359 Kent Street, 436 and 444 MacLaren Street, Ottawa

Planning Rationale Addendum No. 1
Official Plan and Zoning By-law Amendment
March 16, 2023

Prepared for 359 Kent Street Ltd.

Figure 3: Viewplane Analysis along Kent Street

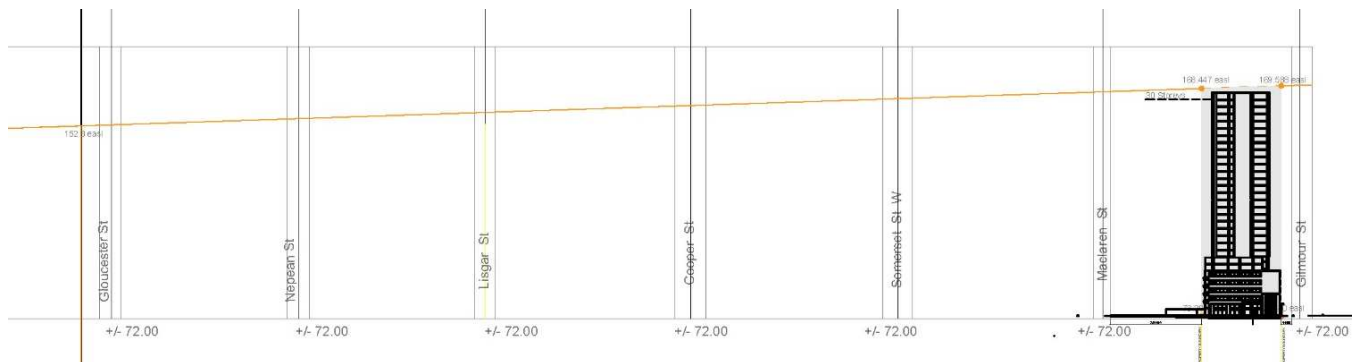
- 2.4.8 Policy 3.9.5.5.11 states that a proposed landmark building shall “fully respect the requirements of the Visual Integrity and Symbolic Primacy of the Parliament Buildings and Other National Symbols guidelines related to building height restrictions”. The submission packages lack information regarding the protection of views of the Parliament Buildings and Other National Symbols. An accurate analysis of views from the various vantage points identified in the Official Plan is required.

The parliamentary view protections do not directly impact the subject property. The proposed height of 30 storeys has been determined to be below a projection of the angular plane described on Schedule C6B (Figure 3).

As discussed within this Addendum, the viewplane for the Parliament Building has been extrapolated south to determine what building height would be permitted without impacting the roofline of Parliament. This has directly led to the proposed height of 30 storeys.
